Addendum 01

Project: CSV L'Harmonie Child Care Addition **Date:** 07 November 2024
158 Bridgeport St E, Waterloo, ON **Pages incl. cover:** 16
Tender No.: 25-28

Architect:	Workshop	Date:	November 6, 2024
Project:	CSV L'Harmonie Daycare Addition	Project No.:	22-058

⑧ Classroom Control Panel
1 : 10

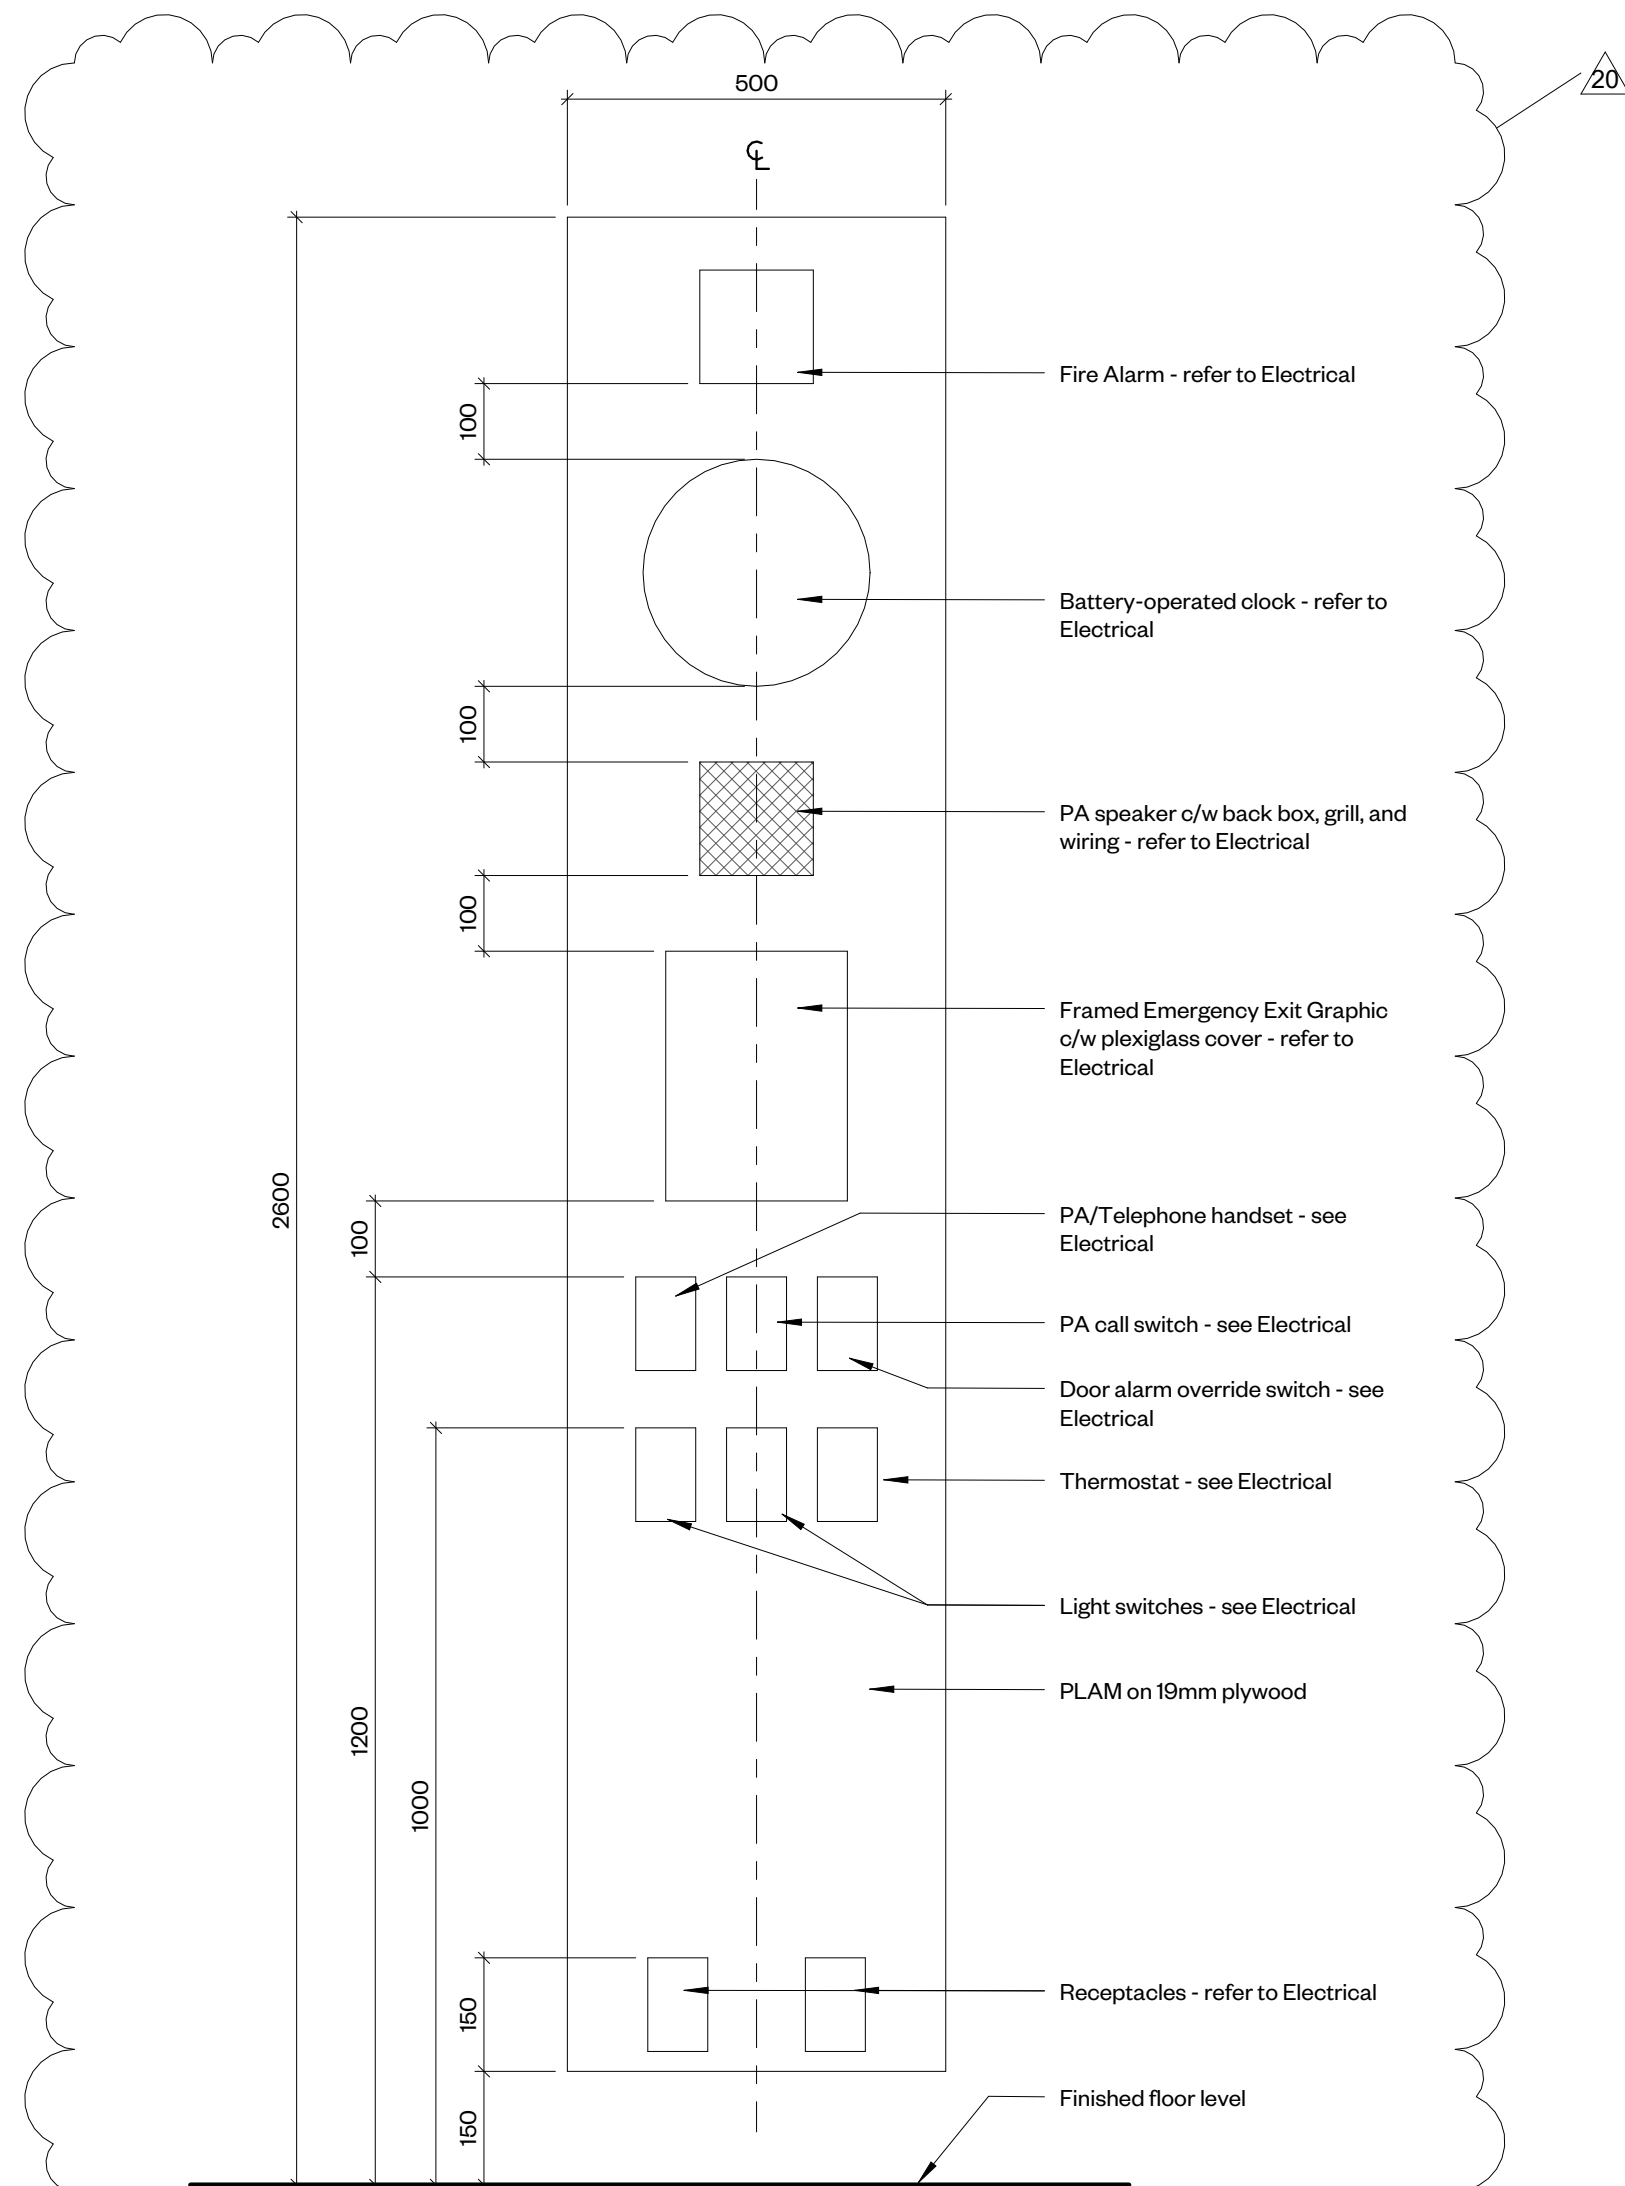
1.05	Addition: Refer to 1/A1.1, 10/A3.0, and S10 on A0.1 for revised window demolition and replacement scope.
1.06	Question: Can architect confirm control panels (COP) are not a millwork/finished carpentry item? Answer: See added detail 8/A6.1. Classroom control panels are to be supplied and installed by the Electrical contractor.
